ATTACHMENT FOUR

PROPOSED TECHNICAL SPECIFICATION REVISIONS

ATTACHMENT FIVE

FSAR MARK-UPS

TABLE 3.11(B)-5

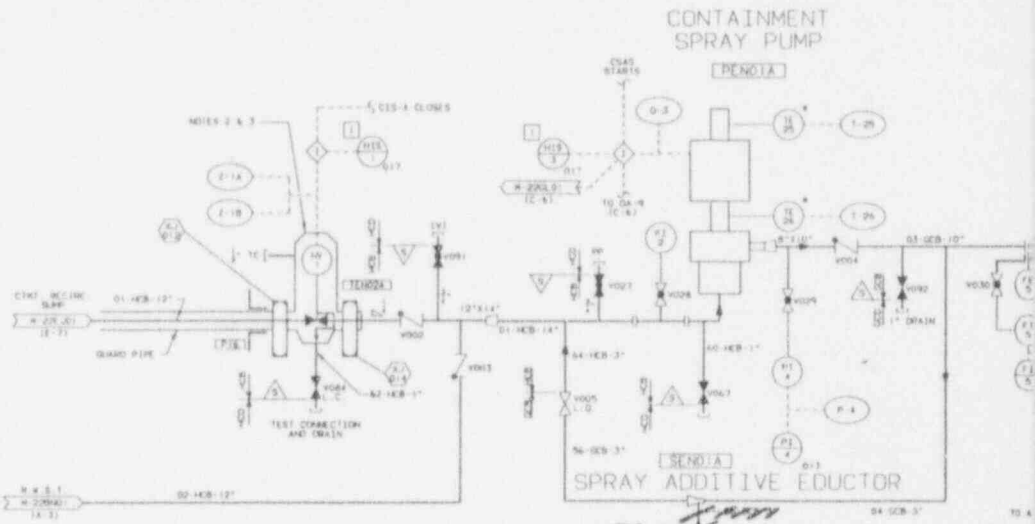
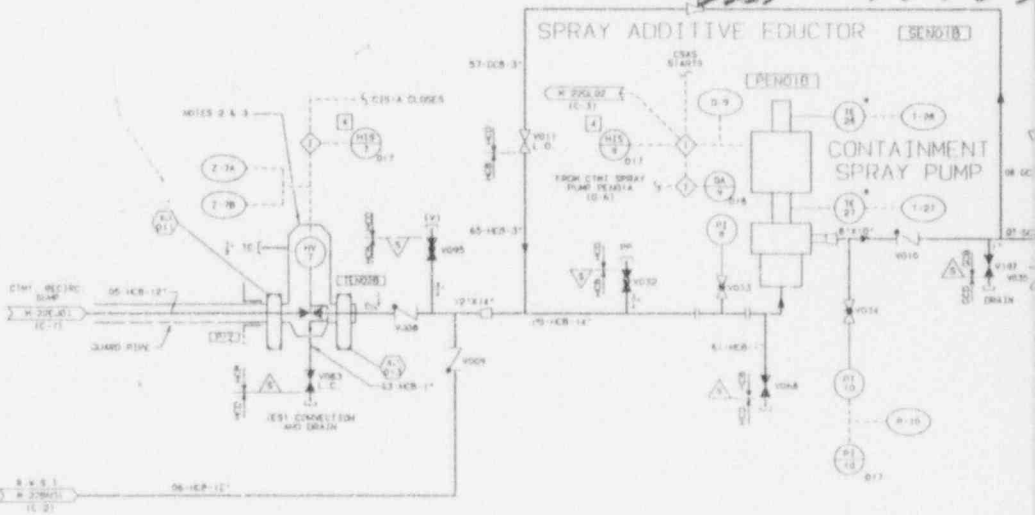
The Callaway design utilizes two redundant trains to supply containment spray for temperature and pressure reduction and fission product removal from the containment atmosphere. Table 3.11(B)-5 identifies the containment spray requirements. The Standard Review Plan indicates that single failures should be evaluated to determine the worst case chemical concentrations. The worst case concentrations ~~resulting from a single failure~~ are pH = 4.0 and pH = **11.0**, as discussed in Section 6.5.2.3.

A caustic spray with an upper limit of pH = 11.0 ^{will be} ~~used in the EQ reviews~~, however, ~~it is recognized that this event will only occur for a short period~~. A boron concentration of 2050 ppm was used in the EQ reviews. The Cycle 4 change to an RWST boron concentration of 2350-2500 ppm has a negligible effect on peak pH, therefore the corrosive effects of the containment spray are not increased. As such, there is no adverse EQ impact arising from this change in RWST boron concentration.

Sprayed Fluid	Injection Phase	
	Aqueous Solution, pH (max.)	11.0 4.0-7.0
	Boric Acid, ppm boron (max./min.)	2,500/2,350
Sprayed Fluid	Recirculation Phase	
	(with continued NaOH addition)	
	Aqueous Solution, pH (max.)	11.0 7.1-11.0
	Boric Acid, ppm boron (max./min.)	2,500/ 2,900 2,007
Sprayed Fluid	Recirculation Phase	
	Aqueous Solution, pH	8.0-10.0
	Boric Acid, ppm boron (max./min.)	2,500/2,900
Final Sump Fluid <i>Equilibrium</i>	Aqueous Solution, pH	8.5-10.0 7.1-9.0
	Boric Acid, ppm boron (max./min.)	2,500/ 2,970 2,007

TABLE 6.5-2 (Sheet 2)

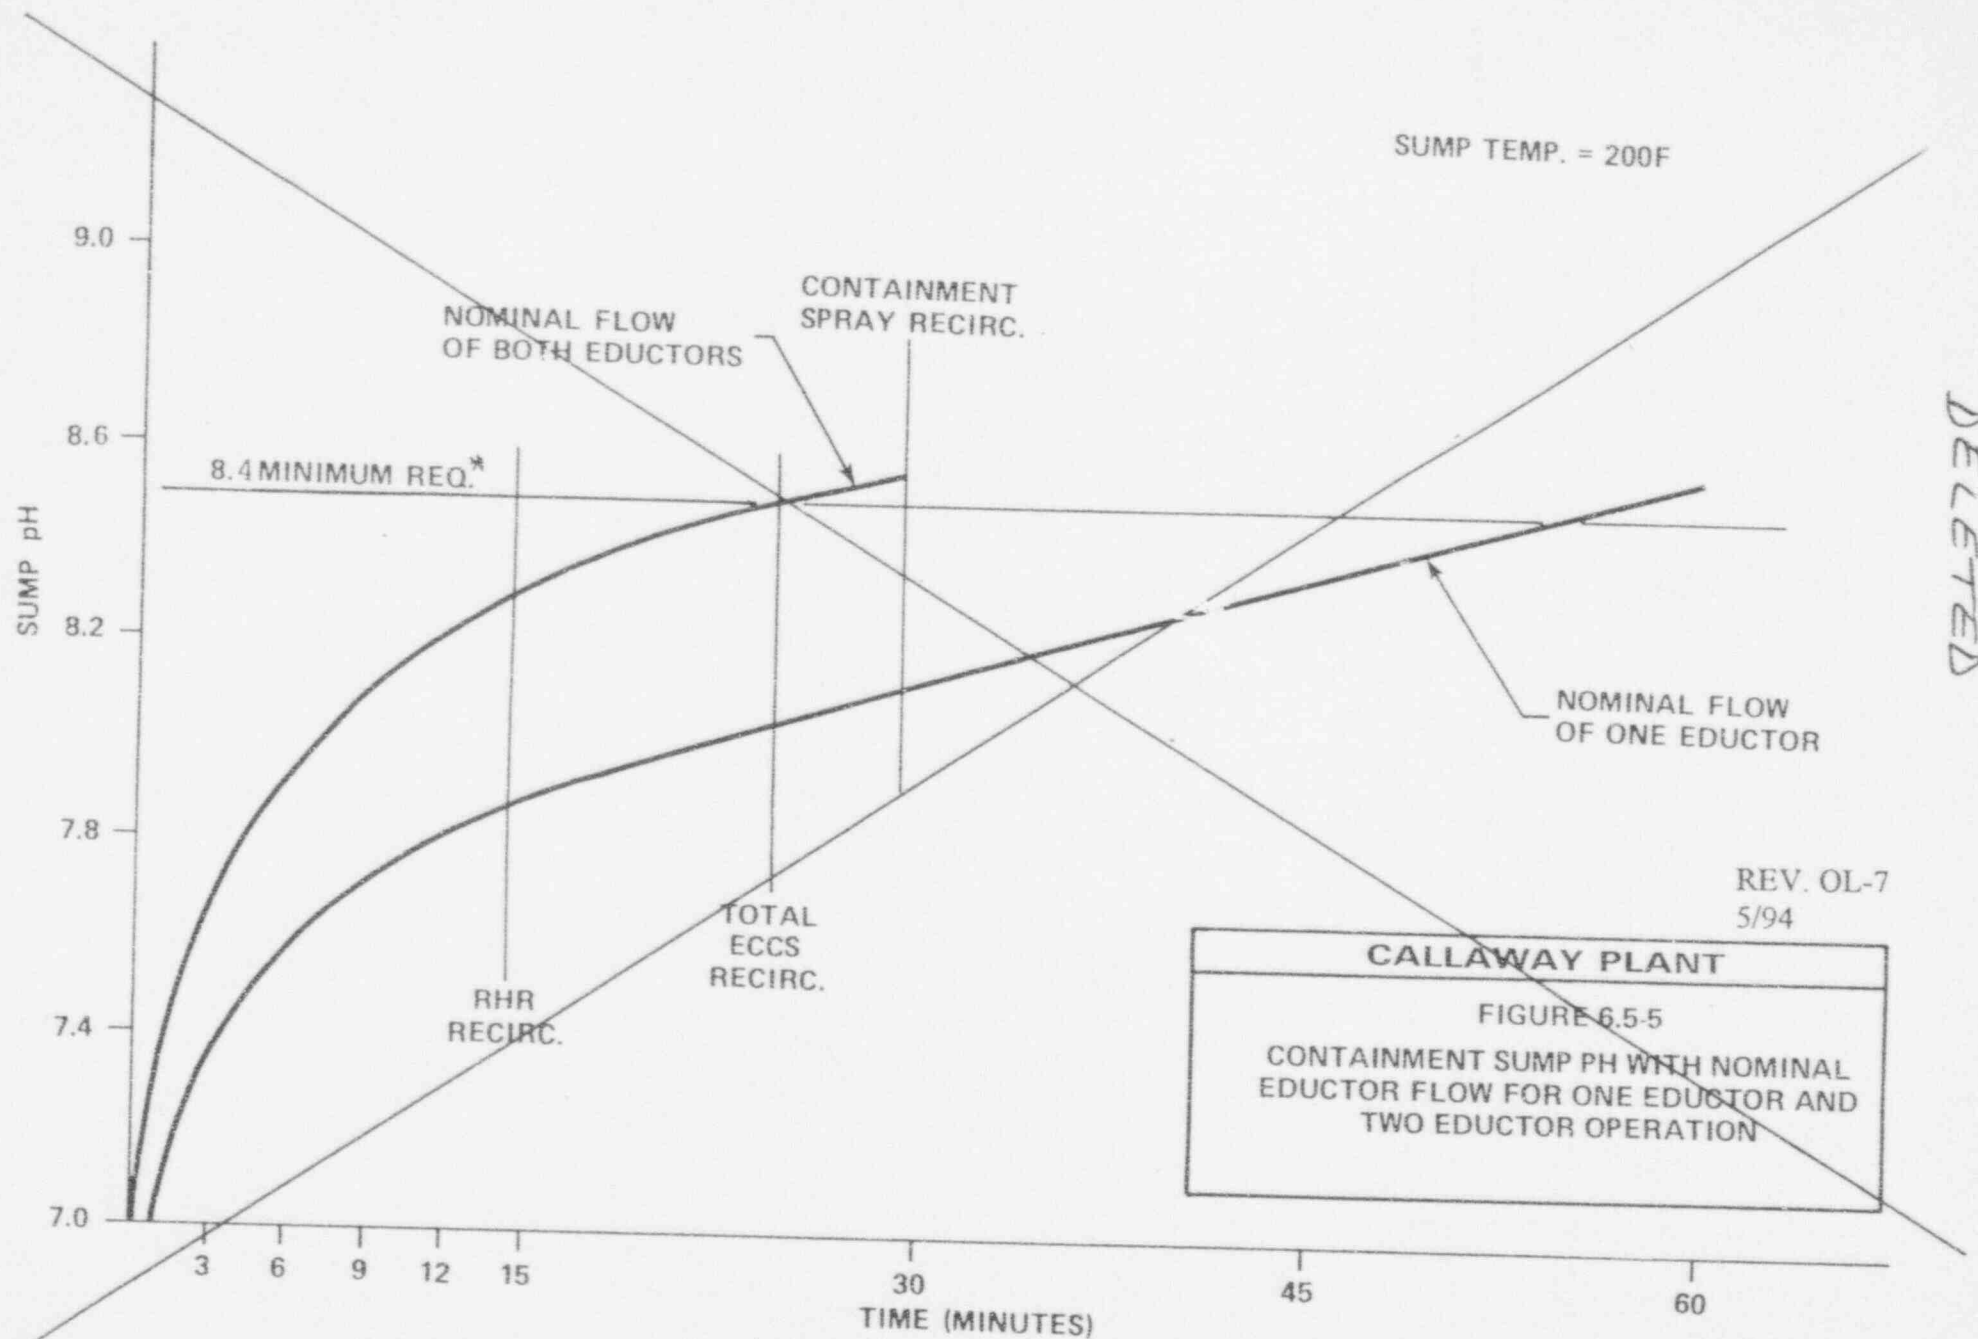
~~4.0-11.0~~ - 7.0
 100
 100
 2,500/2,350
~~0-7,530~~
 37-120

~~8.0-11.0~~ 7.1-11.0
 2,500/~~1,900~~ 2,007
~~10,300~~
 120-255
